### **Plan Change 60 - Maxwell Hills Zone – Reply to Request for Further Information**

**RESPONSE TO REQUEST FOR  
FURTHER INFORMATION  
RESOURCE CONSENT  
APPLICATION  
PLAN CHANGE 60 - MAXWELL  
HILLS ZONE**

The following responses, prepared by Riley Consultants Ltd (RILEY), relate to questions raised by Mr Paul Whyte of Beca Carter Hollings & Ferner Ltd (Beca) on behalf of the Marlborough District Council (MDC), in their letter dated 10 June 2011, requesting further information.

DRAWING No. **04819/6FL-3**

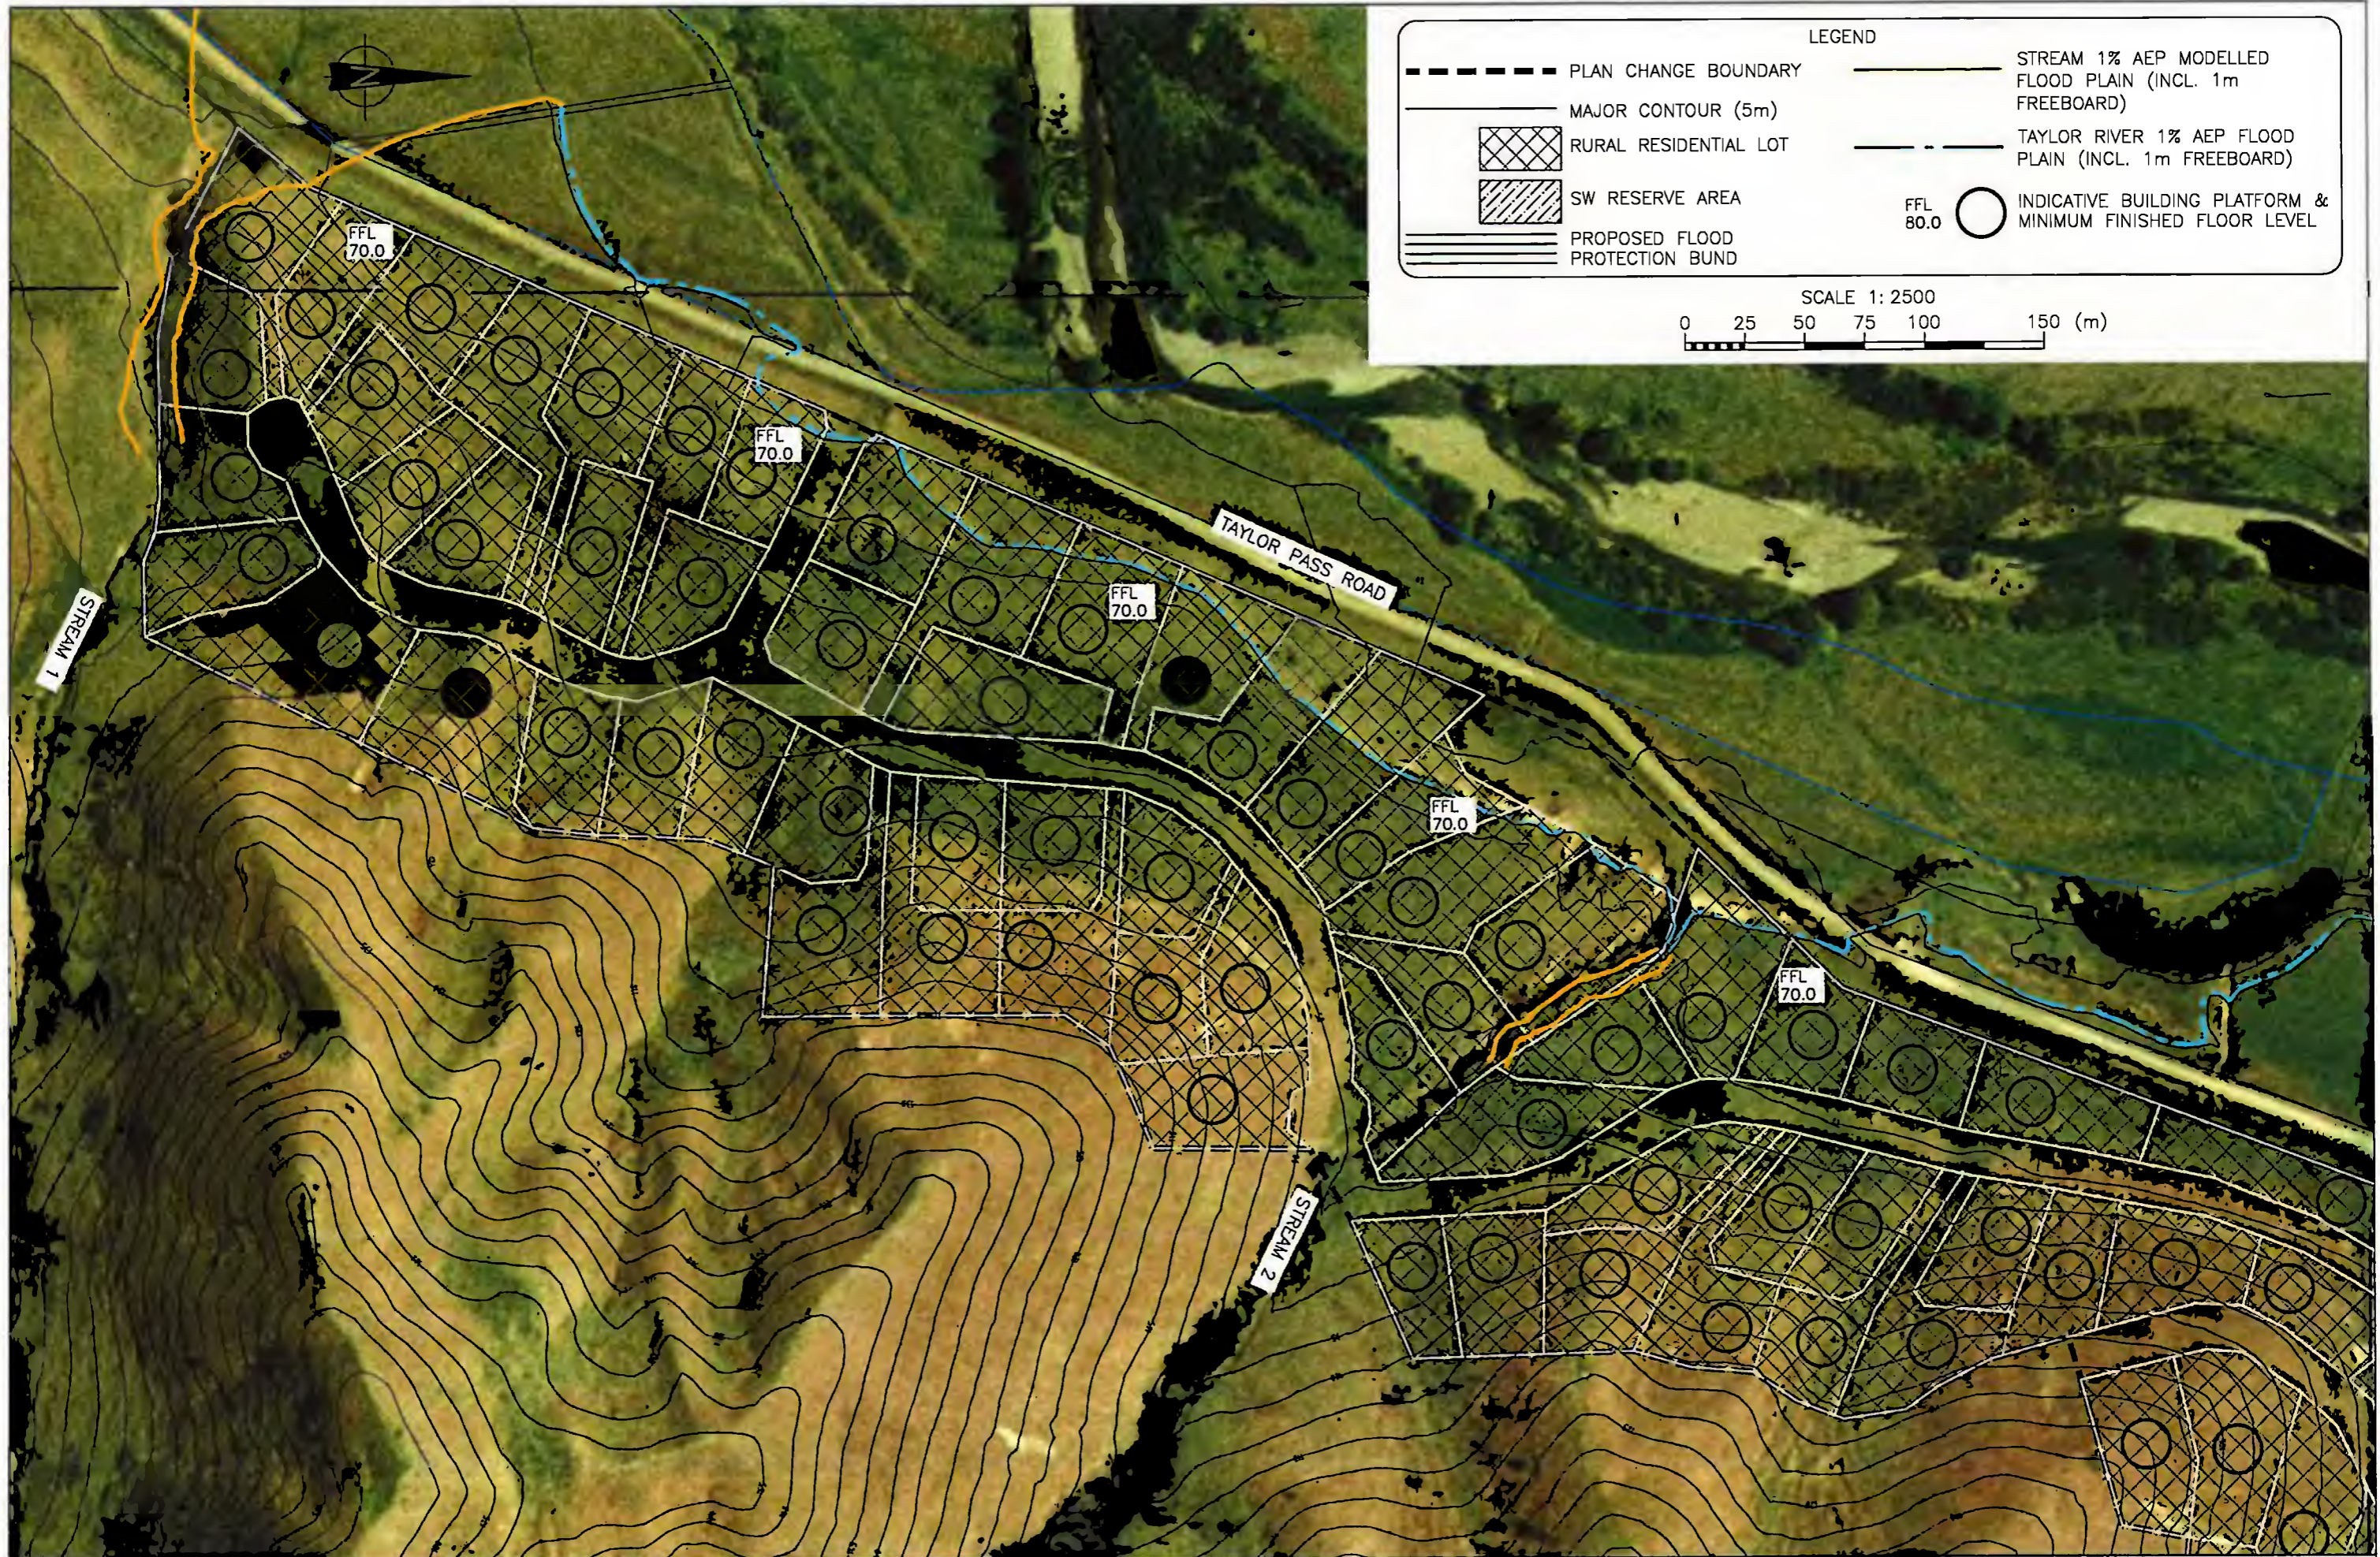
#### **Question 4.4 - Flood Inundation and Protection**

The extent of the estimated 1% AEP Floodplain (including 1 metre freeboard) is shown on RILEY Dwgs: 04819/6FL-1 to 3 (Appendix A). As mentioned earlier, minimum FFLs have also been added to show flood levels along the creek/river.

RILEY Dwgs: 04819/6FL-1 and 2 have been updated and Dwg: 04819/6FL-3 added to better clarify the design flood plain for the Maxwell Creek, Taylor River, Stream 1, and Stream 2. Additional contours have also been provided for clarification.
